**NSLPP MEETING HELD ON 04/06/2025**  
**SECTION 4.55 APPLICATION REPORT**

**ADDRESS:** 115 Blues Point Rd, McMahon's Point

**APPLICATION NO:** DA 205/23/2

**PROPOSAL:** Modification of DA205/2023 for alterations and additions to a dwelling including new lift, formal vehicular access from lane, and new landscaping; proposing changes to lift arrangements and external design refinements to the approved development

Figure 1: Ground floor plan showing lift realigned 450mm outwards from northern wall

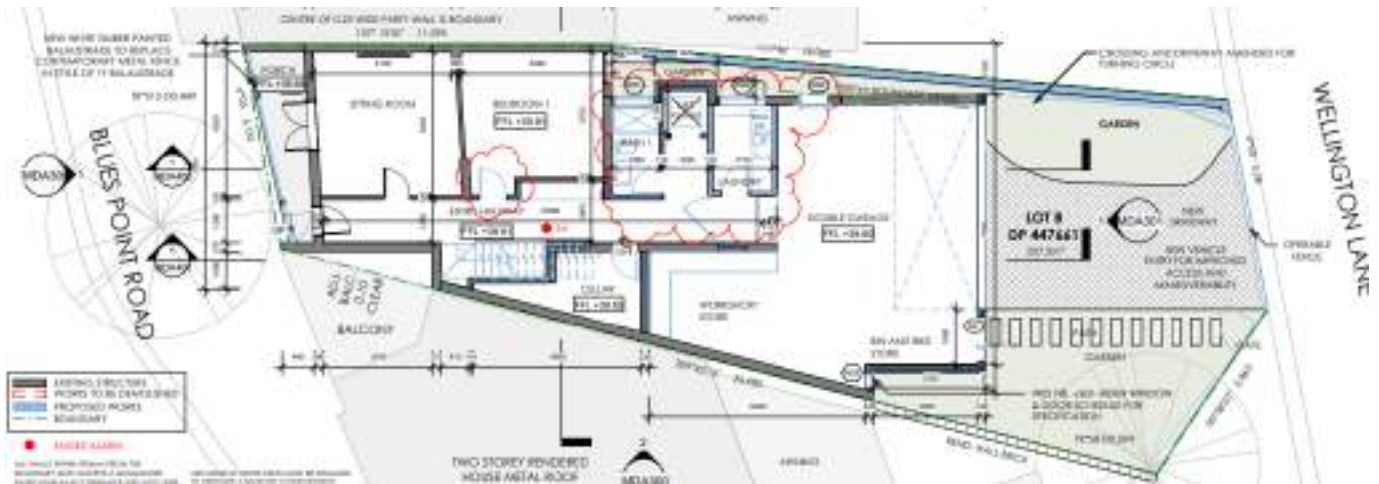
Realign lift to extend 450mm from the northern side elevation – refer to Figures 1 & 2 below.

Shift bedroom door to align with existing entry hallway, refer to Figure 1 above

**Comment** – The proposed design modifications are accepted as being minor, involving realignment of the lift out from the north side wall by 450mm and shifting the internal door to bedroom 2. The potential impacts that may arise from the design modifications are addressed as follows.

*Internal amenity* – Shifting the bedroom 1 door to align with the existing entry hallway maintains the approved internal layout for the alterations and additions, with no impact on amenity.

Figure 2: Northern elevation showing position of lift, re-aligned 450mm outwards from north wall

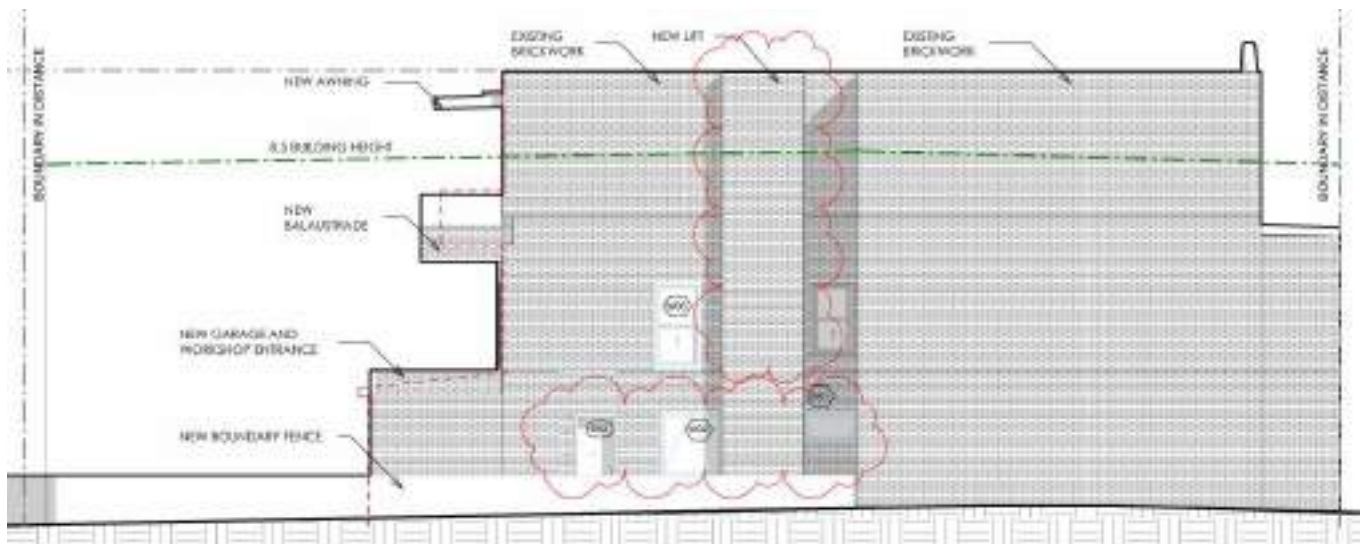
*Rear laneway* - As viewed from Wellington Lane, the lift walls will extend out 450mm from the north side wall. Whilst this will be noticeable from the lane, it will articulate the northern wall without causing any adverse impact to the laneway streetscape. As such the laneway has a utility like rear lane character with varying setbacks and mixed parking arrangements including open parking stands and garages. The lift will be visible as a minor 'step' along the northern wall with matching brick finish, while maintaining visibility of the first and second floor windows as viewed in Figure 5.

Whilst the lift will become visible (rather than be internal to the existing north side wall), its external brick wall construction will integrate with the form of the existing north side brick wall and not cause any significant increase in building bulk. Furthermore the approved rear additions and landscaping will serve to complement the appearance of the development to the laneway.

*Neighbours amenity* - As viewed from the northern neighbour, the lift will be visible from its rear first storey east facing windows whilst maintaining a local outlook to Wellington Lane and the terrace housing adjacent to the rear. Whilst the lift will be visible, realigning it 450mm outwards from the northern wall is not considered to have an intrusive effect on this outlook.

The proposed modification to realign the lift results in a minor change to the form of the north facing wall, stepping out 450mm with a length of 1.84m. Relative to the overall length of the north side wall, the lift represents approximately 10% and will not result in any significant increase in building bulk along with no increase in height.
